Product Change Notice (PCN)

Subject: Addition of production sites for RL78/G11(16pin), G1P, I1D, G1A.

**Difference of specification
(RL78 family HWQFN products)
3mm×3mm 0.5mm pitch 16pin
4mm×4mm 0.5mm pitch 24pin
5mm×5mm 0.5mm pitch 32pin**

MCP-AB-22-0089

Dimension comparison: 3mm×3mm 0.5mm pitch 16pin HWQFN

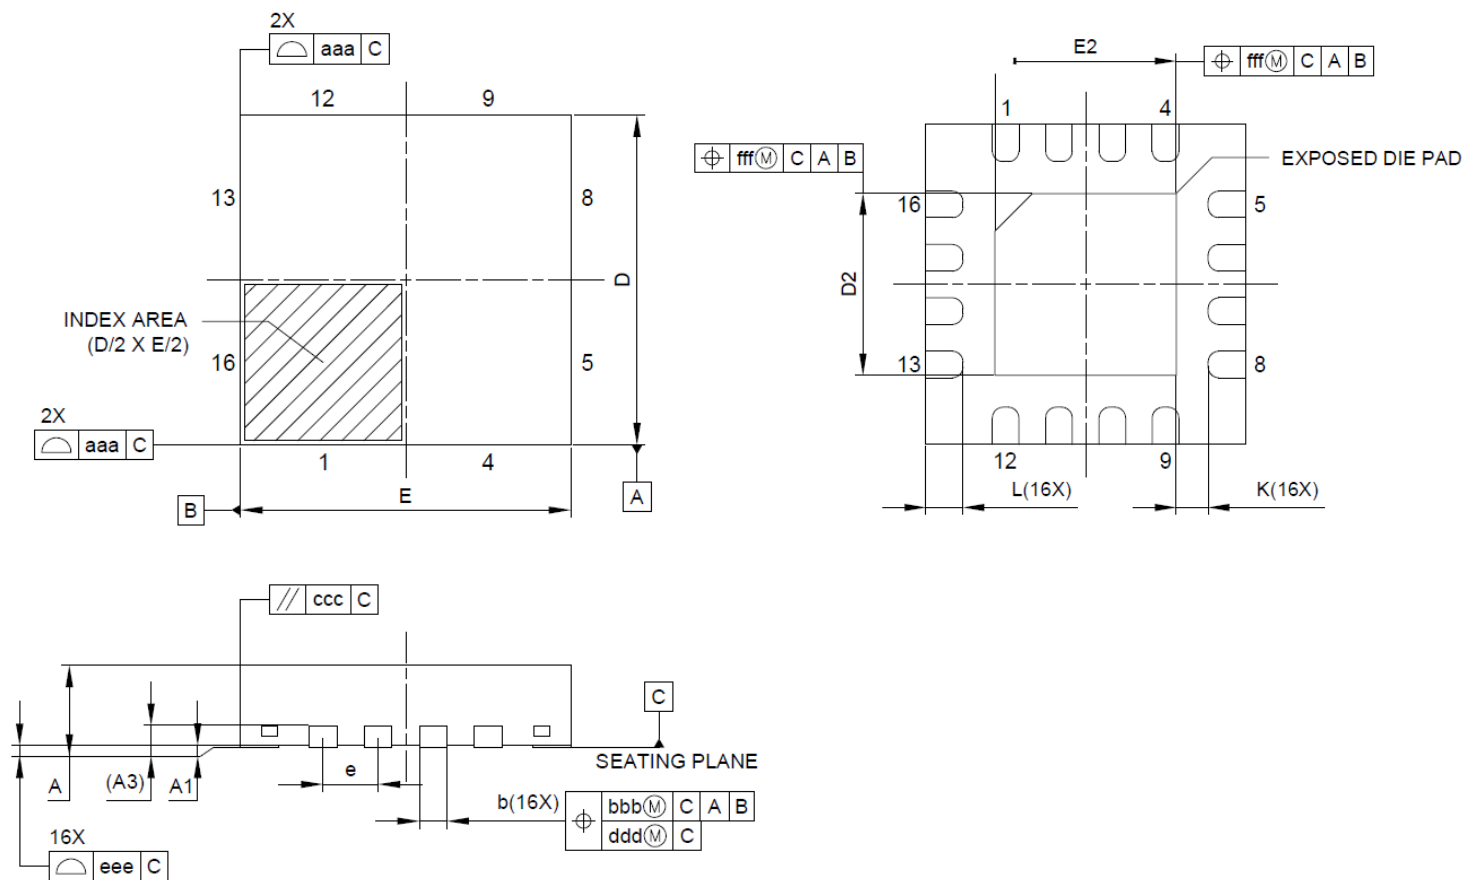
UTAC Symbol	3x3mm 16pin HWQFN PWQN0016KE-A			Greatek Symbol	3x3mm 16pin HWQFN PWQN0016KD-A		
	Dimension in Millimeters				Dimension in Millimeters		
	Min	Nom	Max		Min	Nom	Max
A	-	-	0.80	A	-	-	0.80
A1	0.00	-	0.05	A1	0.00	0.02	0.05
A3	0.20 REF.			A3	0.203 REF.		
b	0.20	0.25	0.30	b	0.20	0.25	0.30
D	-	3.00	-	D	3.00 BSC		
E	-	3.00	-	E	3.00 BSC		
e	-	0.50	-	e	0.50 BSC		
N	16			-	-	-	-
L	0.25	0.35	0.45	L	0.30	0.35	0.40
K	0.20	-	-	K	0.20	-	-
D2	1.60	1.70	1.80	D2	1.65	1.70	1.75
E2	1.60	1.70	1.80	E2	1.65	1.70	1.75
aaa	-	-	0.15	aaa	0.15		
bbb	-	-	0.10	bbb	0.10		
ccc	-	-	0.10	ccc	0.10		
ddd	-	-	0.05	ddd	0.05		
eee	-	-	0.08	eee	0.08		
-	-	-	-	fff	0.10

Dimension comparison: 4mm×4mm 0.5mm pitch 24pin HWQFN

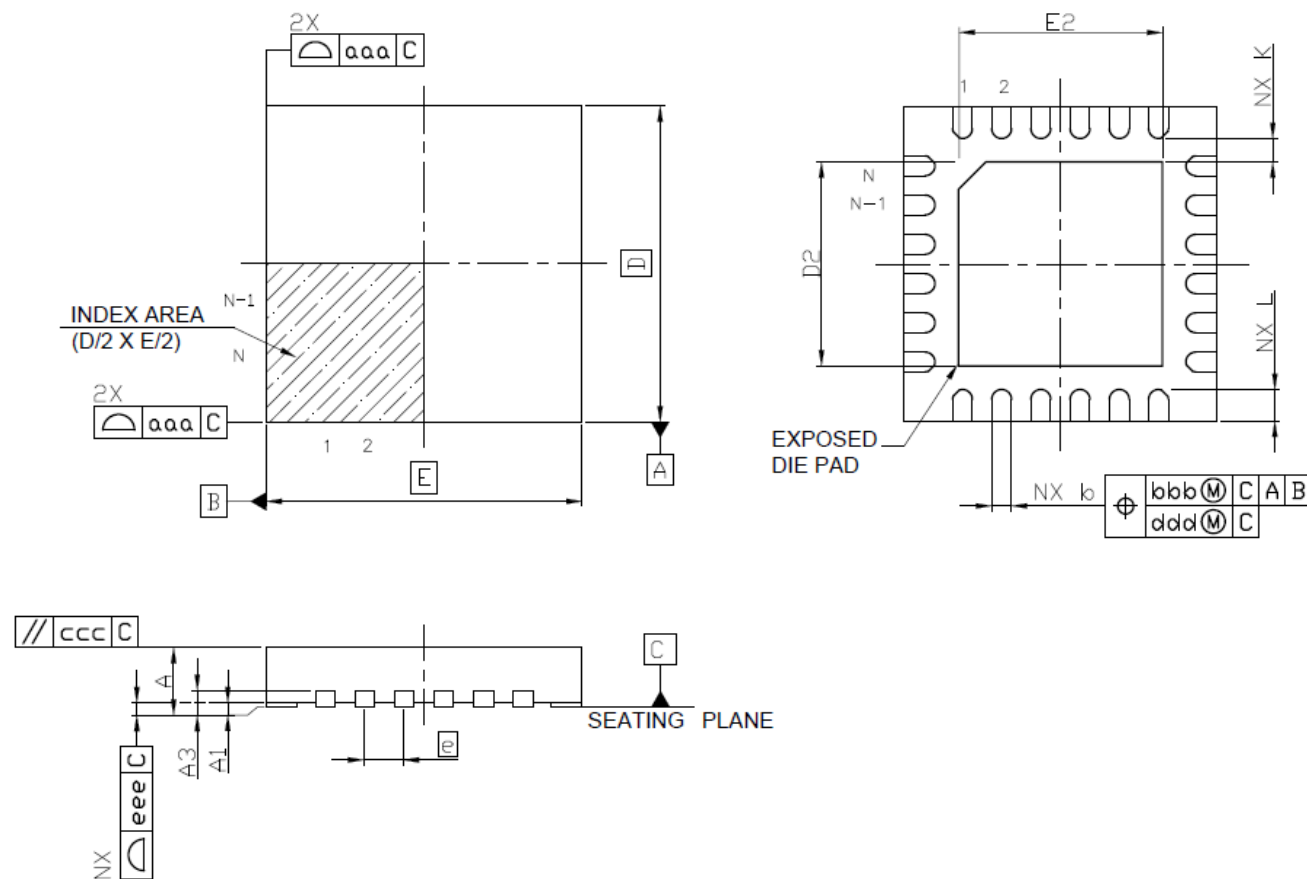
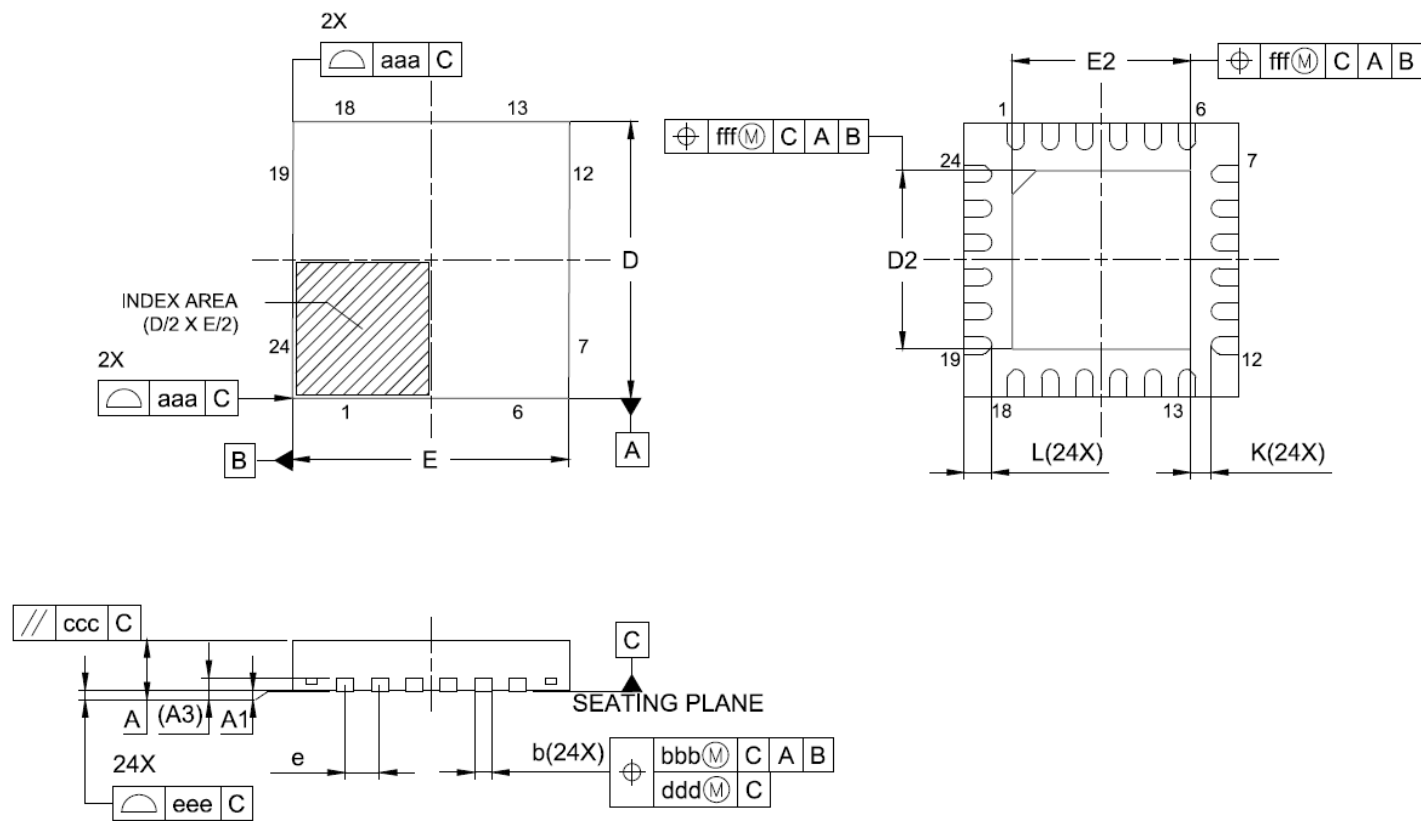
UTAC Symbol	4x4mm 24pin HWQFN PWQN0024KH-A			Greatek Symbol	4x4mm 24pin HWQFN PWQN0024KF-A		
	Dimension in Millimeters				Dimension in Millimeters		
	Min	Nom	Max		Min	Nom	Max
A	-	-	0.80	A	-	-	0.80
A1	0.00	-	0.05	A1	0.00	0.02	0.05
A3	0.20 REF.			A3	0.203 REF.		
b	0.20	0.25	0.30	b	0.18	0.25	0.30
D	-	4.00	-	D	4.00 BSC		
E	-	4.00	-	E	4.00 BSC		
e	-	0.50	-	e	0.50 BSC		
N	24			-	-	-	-
L	0.30	0.40	0.50	L	0.35	0.40	0.45
K	0.20	-	-	K	0.20	-	-
D2	2.50	2.60	2.70	D2	2.55	2.60	2.65
E2	2.50	2.60	2.70	E2	2.55	2.60	2.65
aaa	-	-	0.15	aaa	0.15		
bbb	-	-	0.10	bbb	0.10		
ccc	-	-	0.10	ccc	0.10		
ddd	-	-	0.05	ddd	0.05		
eee	-	-	0.08	eee	0.08		
-	-	-	-	fff	0.10

Dimension comparison: 5mm×5mm 0.5mm pitch 32pin HWQFN

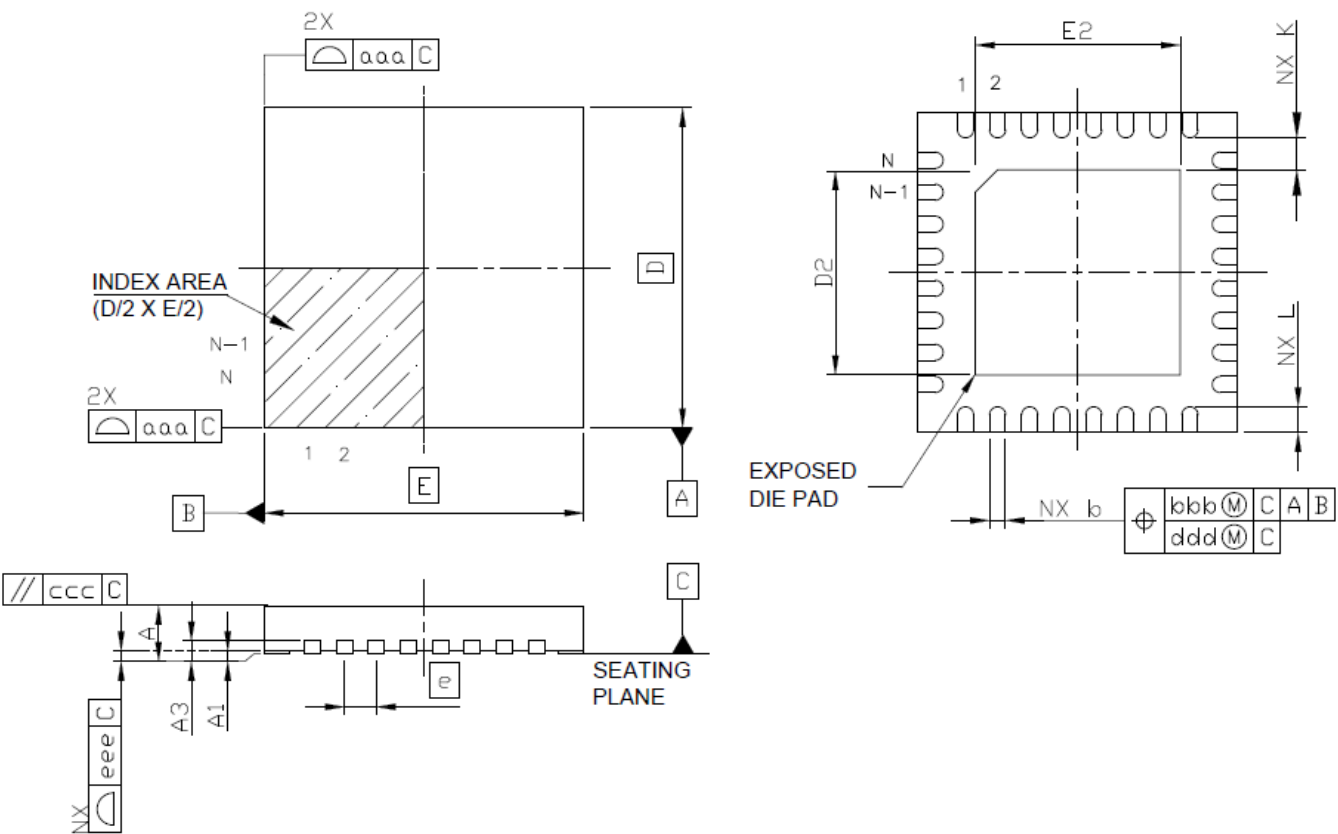
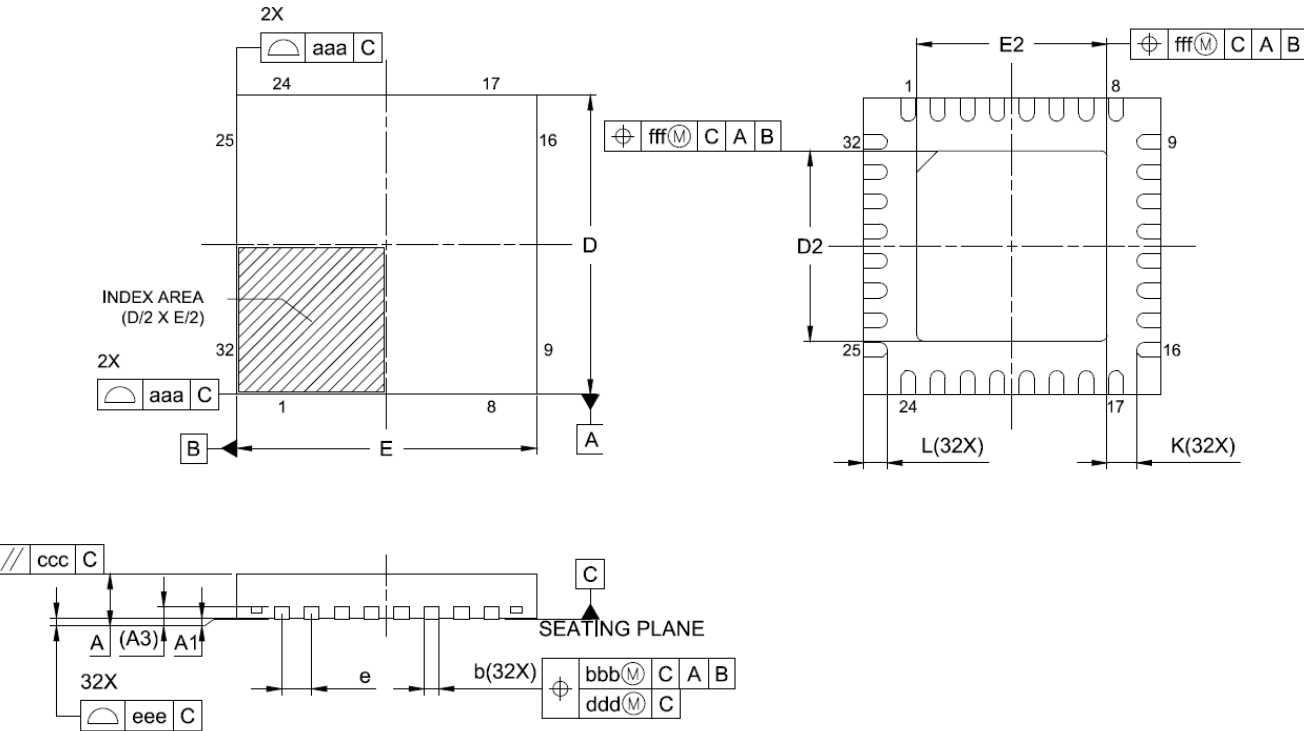
UTAC Symbol	5x5mm 32pin HWQFN PWQN0032KG-A			Greatek Symbol	5x5mm 32pin HWQFN PWQN0032KE-A		
	Dimension in Millimeters				Dimension in Millimeters		
	Min	Nom	Max		Min	Nom	Max
A	-	-	0.80	A	-	-	0.80
A1	0.00	-	0.05	A1	0.00	0.02	0.05
A3	0.20 REF.			A3	0.203 REF.		
B	0.20	0.25	0.30	b	0.18	0.25	0.30
D	-	5.00	-	D	5.00 BSC		
E	-	5.00	-	E	5.00 BSC		
e	-	0.50	-	e	0.50 BSC		
N	32			N	-	-	-
L	0.30	0.40	0.50	L	0.35	0.40	0.45
K	0.20	-	-	K	0.20	-	-
D2	3.10	3.20	3.30	D2	3.15	3.20	3.25
E2	3.10	3.20	3.30	E2	3.15	3.20	3.25
aaa	-	-	0.15	aaa	0.15		
bbb	-	-	0.10	bbb	0.10		
ccc	-	-	0.10	ccc	0.10		
ddd	-	-	0.05	ddd	0.05		
eee	-	-	0.08	eee	0.08		
-	-	-	-	fff	0.10

Package structure image

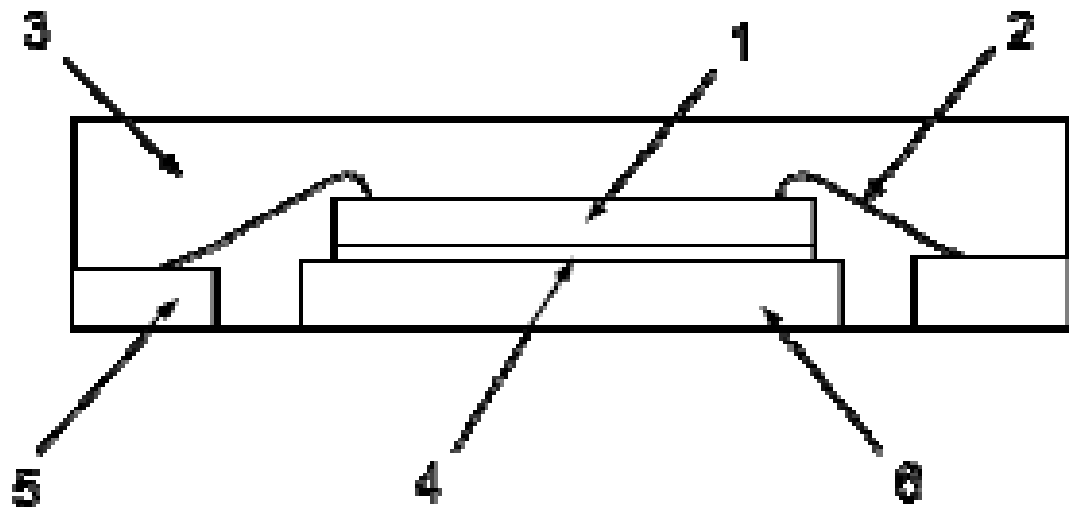
* Different materials will be used at UTAC but their structure is same as those conventionally used.

Marking visibility

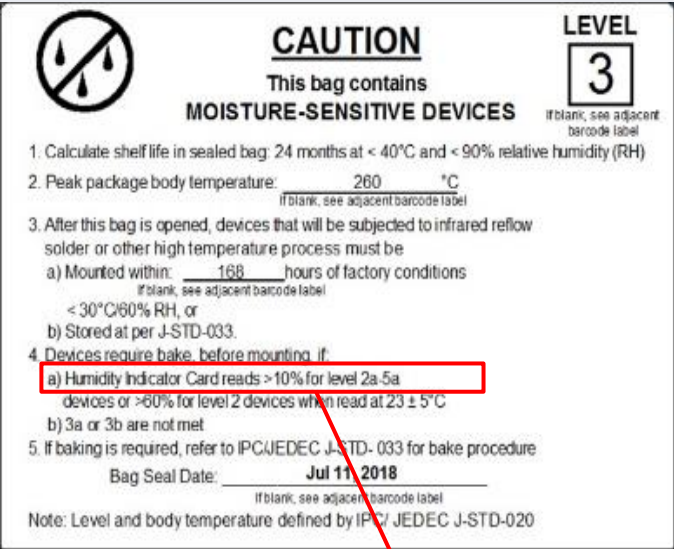
Change the marking font.

Packing specification for Tray

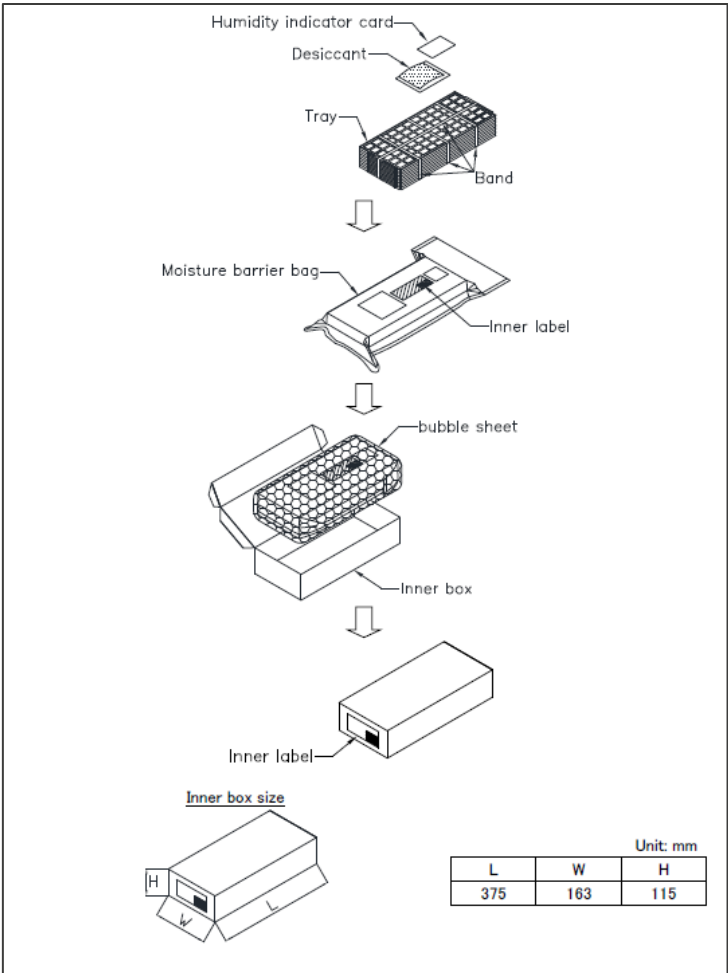
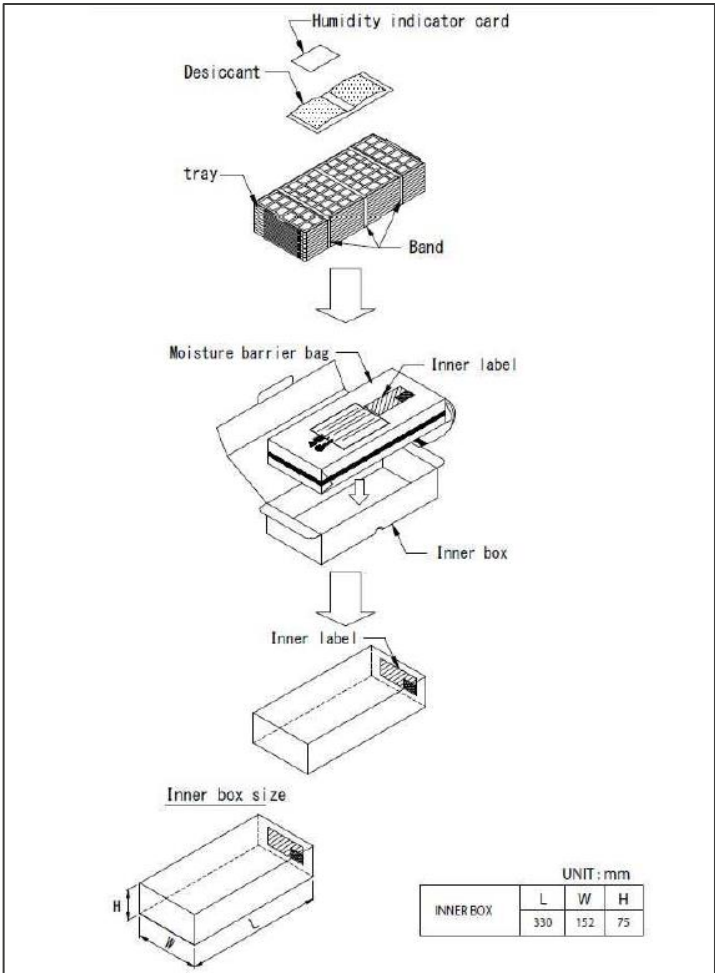
Packing material	Tray	
	Additional (UTAC)	Existing (KYEC)
Number of trays contained in the inner box	•Tray : 8 trays+ 1 cover 	•Tray : 8 trays+ 1 cover 
Band	•Band : 4 (3 on the short side + 1 on the long side)	•Band : 3 (3 on the short side)
Desiccant	•Weight : 33g 	•Weight : 25g+25g

Packing material	Tray	
	Additional (UTAC)	Existing (KYEC)
Moisture barrier bag *Refer to page 18 for printed characters.	<div>•Size : 228.6mm×508mm</div> <div>Inner label</div> <div>Caution label</div> <div></div>	<div>•Size : 250mm×510mm</div> <div>Inner label</div> <div></div>
Inner box	<div>•Size : 163mm×375mm×115mm</div> <div> Bubble sheet</div> <div> Inner Box Filament tape Inner label</div>	<div>•Size : 152mm×330mm×75mm</div> <div></div> <div> Inner Box</div> <div> Inner label</div>

Dimension comparison: 3mm×3mm 16pin HWQFN Emboss tape

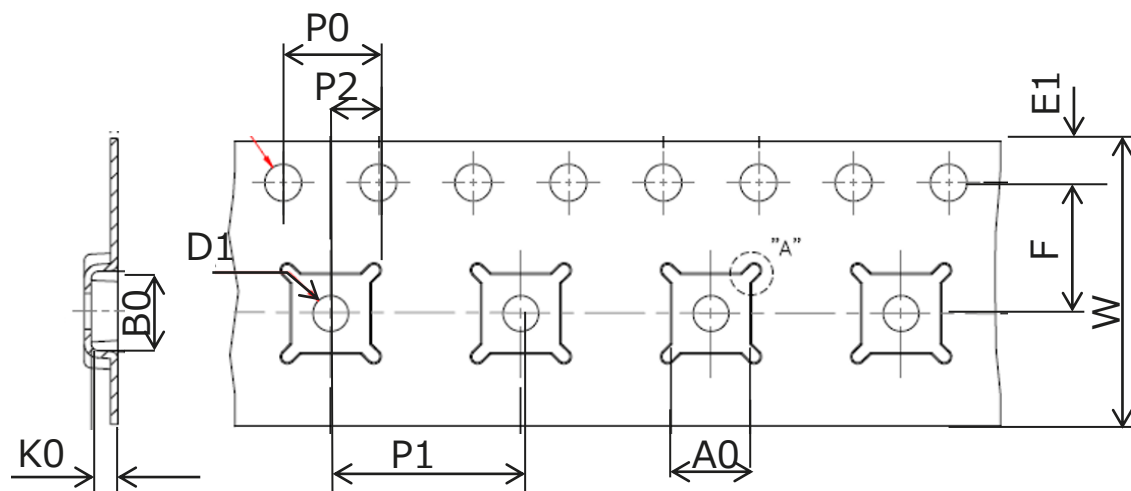
Symbol	Additional (UTAC)	Existing (KYEK)
A0	3.30	3.30
B0	3.30	3.30
K0	1.10	1.10
P1	8.00	8.00
W	12.00	12.00
E1	1.75	1.75
P0	4.00	4.00
F	5.50	5.50
P2	2.00	2.00
D1	Φ1.50MIN	Φ1.60

Dimension comparison: 4mm×4mm 24pin HWQFN Emboss tape

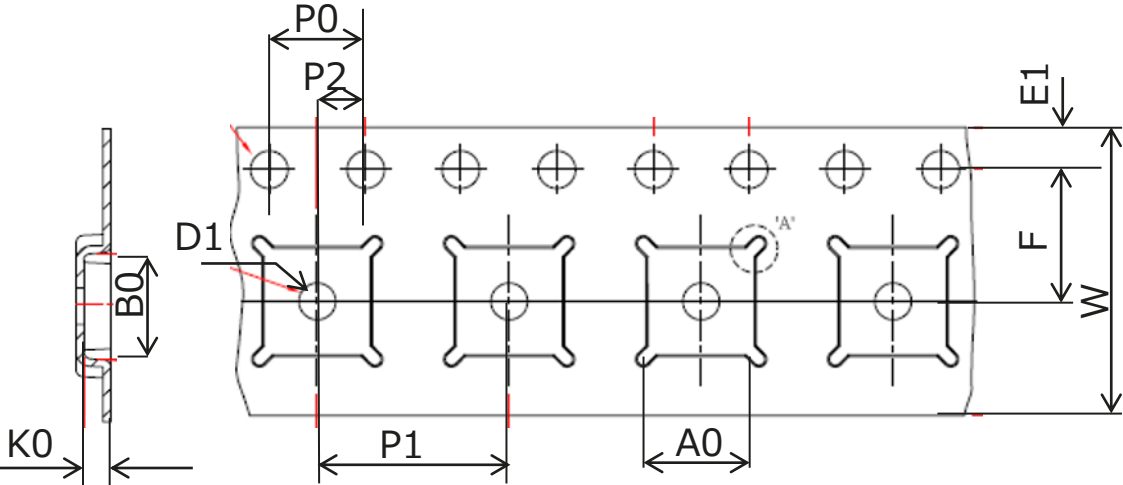
Symbol	Additional (UTAC)	Existing (KYEK)
A0	4.30	4.25
B0	4.30	4.25
K0	1.10	1.10
P1	8.00	8.00
W	12.00	12.00
E1	1.75	1.75
P0	4.00	4.00
F	5.50	5.50
P2	2.00	2.00
D1	Φ1.50MIN	Φ1.60

Dimension comparison: 5mm×5mm 32pin HWQFN Emboss tape

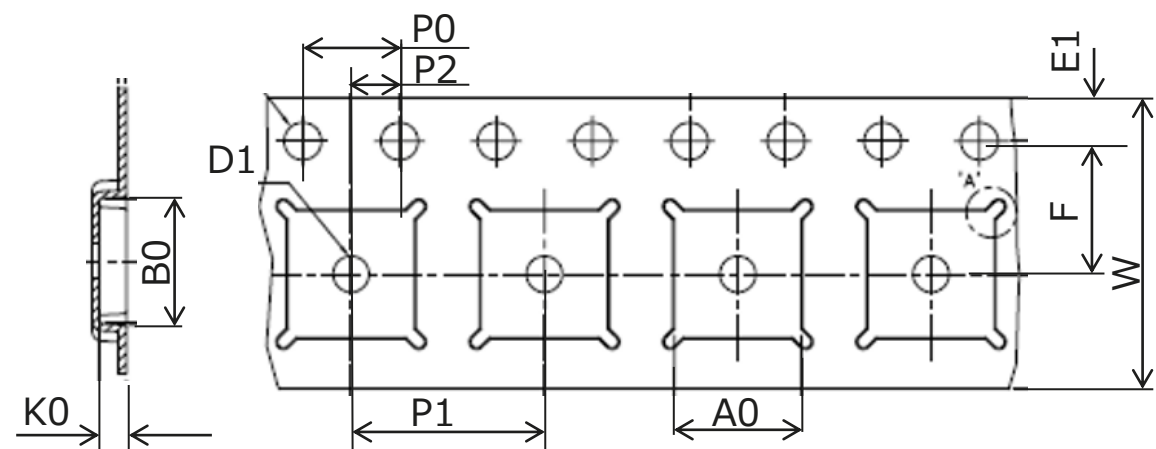
Symbol	Additional (UTAC)	Existing (KYEK)
A0	5.25	5.30
B0	5.25	5.30
K0	1.10	1.10
P1	8.00	8.00
W	12.00	12.00
E1	1.75	1.75
P0	4.00	4.00
F	5.50	5.50
P2	2.00	2.00
D1	Φ1.50MIN	Φ1.60

Dimension comparison: Reel (HWQFN common)

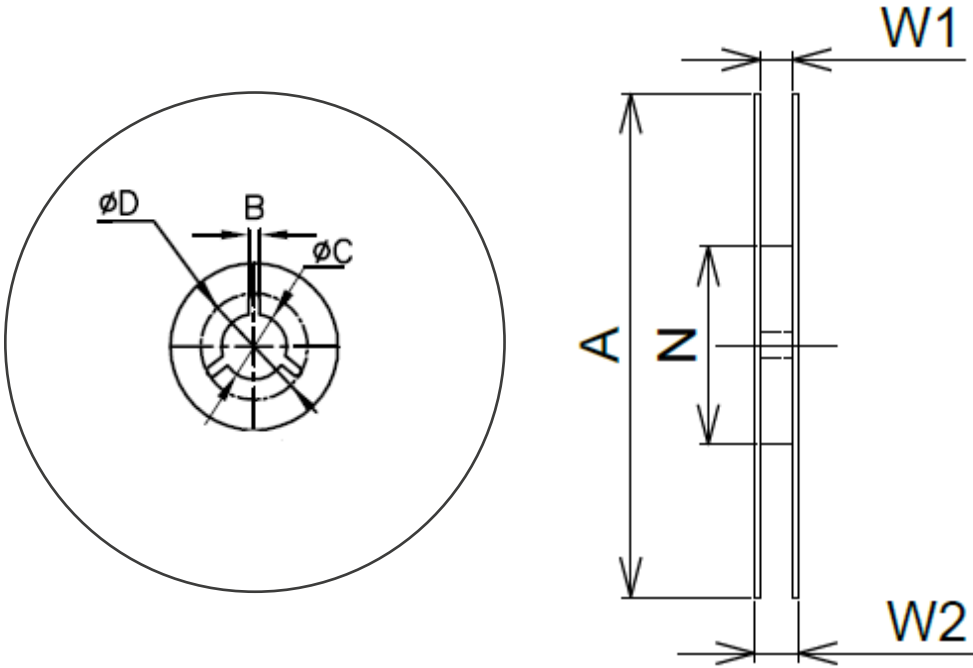
Symbol	Additional (UTAC)	Existing (KYEK)
B	1.5	2.0
ϕC	13.0	13.0
ϕD	20.2	21.0
A	330	330
N	100	102
W1	12.4	12.8
W2	18.4	18.4
